PR#: PR-51
FRN#: 78FR56775
NRC DOCKET#: NRC-2012-0246
SECY DOCKET DATE: 12/19/13
TITLE: Waste Confidence—Continued Storage of Spent Nuclear Fuel
COMMENT#: 00541

**Pilgrim Watch Comment Regarding the NRC Proposed Waste Confidence Rule –
Continued Storage Spent Nuclear Fuel [RIN 3150-AJ20-NRC 2012-0246],
December 19, 2013**

Mary Lampert
Pilgrim Watch, Director
148 Washington Street
Duxbury, MA 02332
Tel. 781-934-0389
Email: mary.lampert@comcast.net
December 19, 2013

Figure 1 The Bathtub Curve

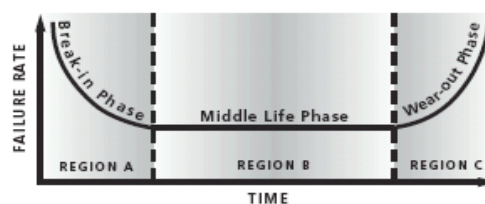
14. **No analysis of age degradation of the pool and refueling cavity for the 60 years following license expiration.** Pilgrim for example was built in the late 60's when Lyndon Johnson was President and the NRC Confidence Decision assumes that the pool would have structural integrity through 2092. There is neither industry experience to rely on nor any other basis for that determination. Engineers explain the aging phenomenon by using what is known as the “Bathtub Curve.” The curve is a graph of failure rate according to age. The failure rate is relatively high in the beginning when “kinks” are being worked out; it flattens out during the middle life phase; and it rises again sharply in the end-of-life or at the “wear-out phase.” On average, 20 to 30 years usually marks the beginning of the wear-out phase. And the rate of corrosion is not linear over time.
